## APPROVED MINUTES

RE: Minutes from the October 17, 2019 Standards Committee Meeting

STANDARD SPECIFICATIONS, SPECIAL PROVISIONS AND STANDARD DRAWINGS  
REVISION TO STANDARD SPECIFICATIONS

E 503-BATJ-02 TERMINAL JOINT, TYPE PCCP (WITH MARKUPS)

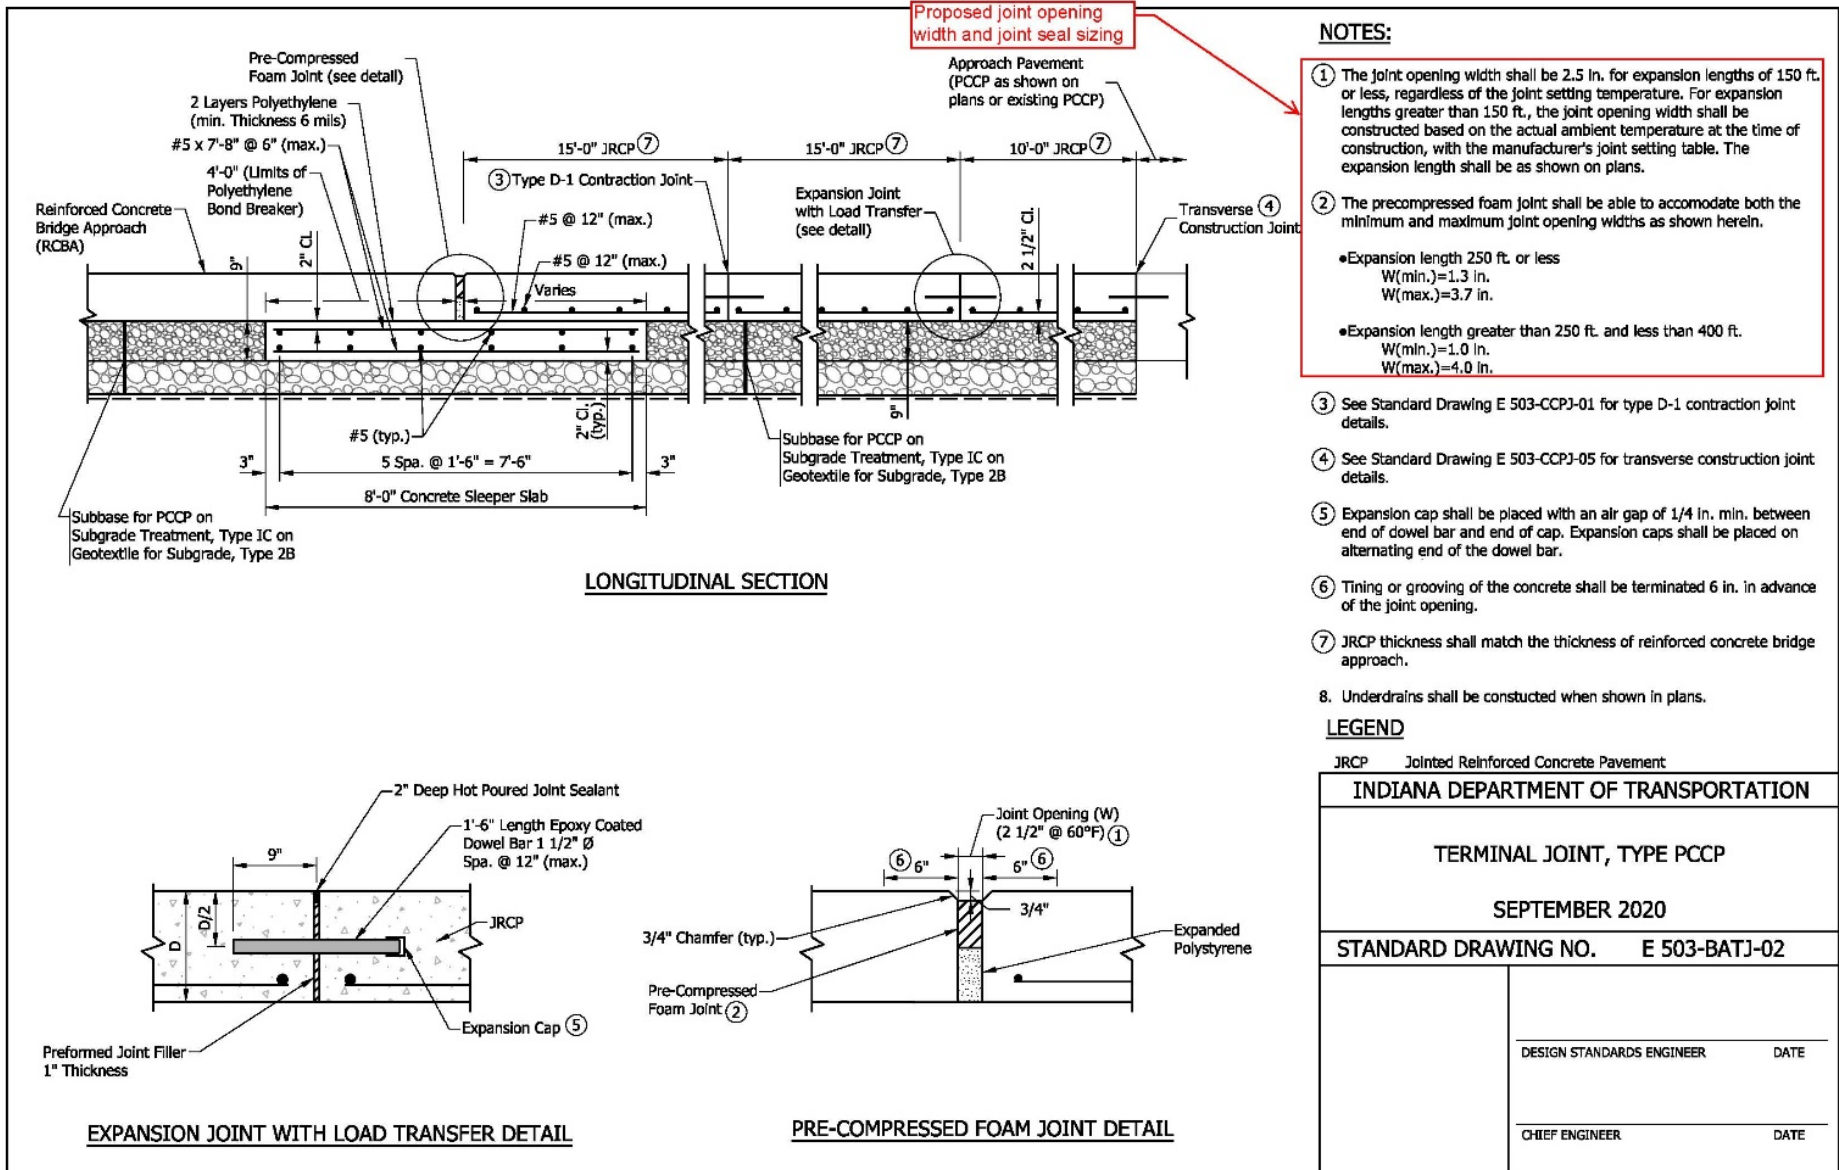
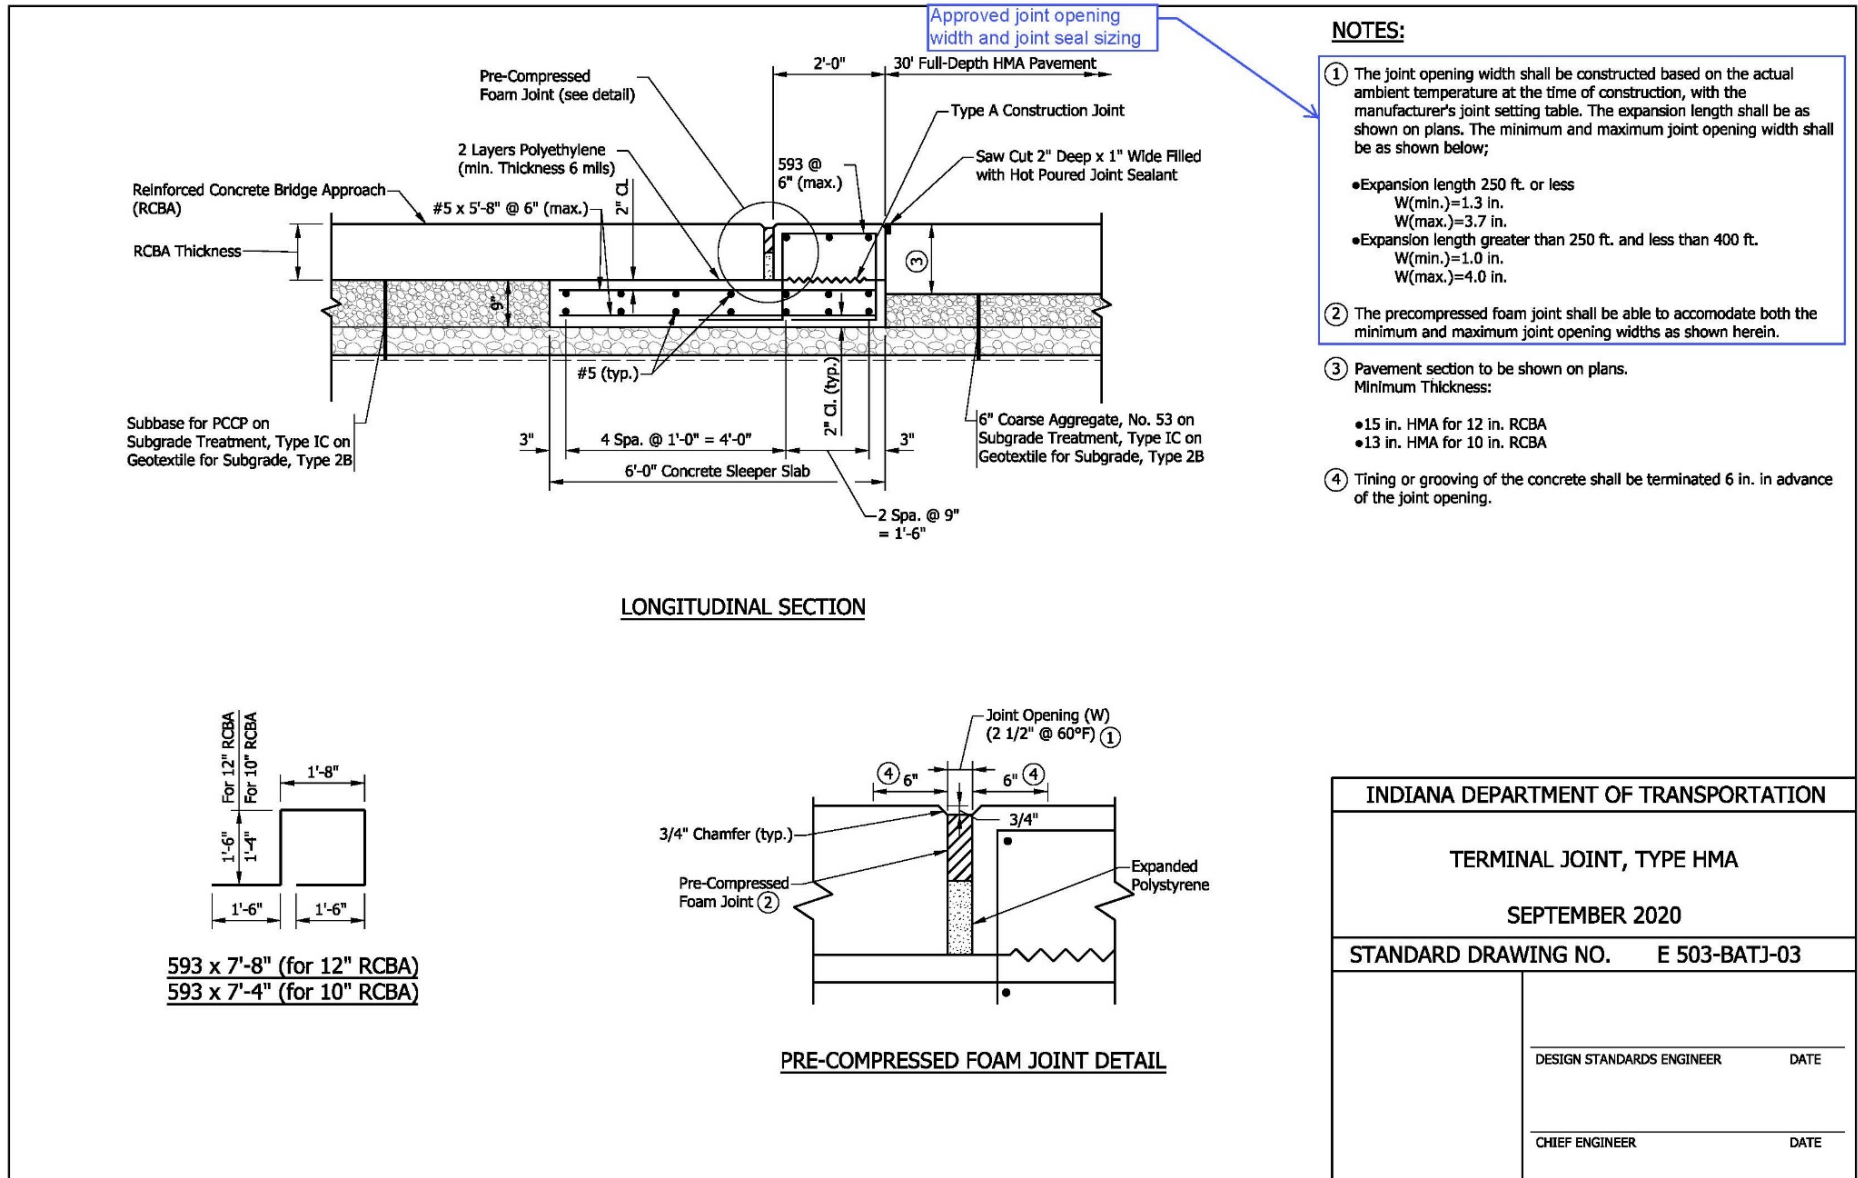
PROBLEM(S) ENCOUNTERED: The terminal joint standard drawings that were submitted and approved at the July 18, 2019 Standard Committee Meeting indicate that the setting width of the pre-compressed foam is to be determined based on actual ambient temperature at the time of construction. Concerns were raised at the Indiana Constructors, Inc. (ICI) meeting on August 8, 2019 about this variability in joint setting widths.

PROPOSED SOLUTION: In order to address the variable joint setting width concern, INDOT reviewed the thermal movements and determined conditions which would allow a constant setting width, regardless of changes in ambient temperature. The proposed joint setting width is constant for expansion lengths less than or equal to 150 ft., which will apply to most terminal joint installation. The joint setting width will remain dependant on ambient temperature for expansion lengths greater than 150 ft.

- NOTES:**
- ① The joint opening width shall be constructed based on the actual ambient temperature at the time of construction, with the manufacturer's joint setting table. The expansion length shall be as shown on plans. The minimum and maximum joint opening width shall be as shown below;

- Expansion length 250 ft. or less  
W(min.)=1.3 in.  
W(max.)=3.7 in.
    - Expansion length greater than 250 ft. and less than 400 ft.  
W(min.)=1.0 in.  
W(max.)=4.0 in.

This item was introduced and presented by Mr. Orton, assisted by Mr. White, who explained that the terminal joint standard drawings that were submitted and approved at the July 18, 2019 Standards Committee Meeting show that the setting width of the pre-compressed foam shall be determined based on actual ambient temperature at the time of construction. Concerns were raised at the Indiana Constructors, Inc., ICI, meeting on August 8, 2019 about this variability in joint setting widths.

Mr. White provided a rather detailed explanation of this process with his PowerPoint presentation. Mr. White explained that in order to address the variable joint setting width concern, the Department reviewed the thermal movements and determined conditions which would allow a constant setting width, regardless of changes in ambient temperature. The proposed joint setting width, as shown above, will be constant for expansion lengths less than or equal to 150 ft, which will apply to most terminal joint installations. The joint setting width will remain dependent on ambient temperature for expansion lengths greater than 150 ft.
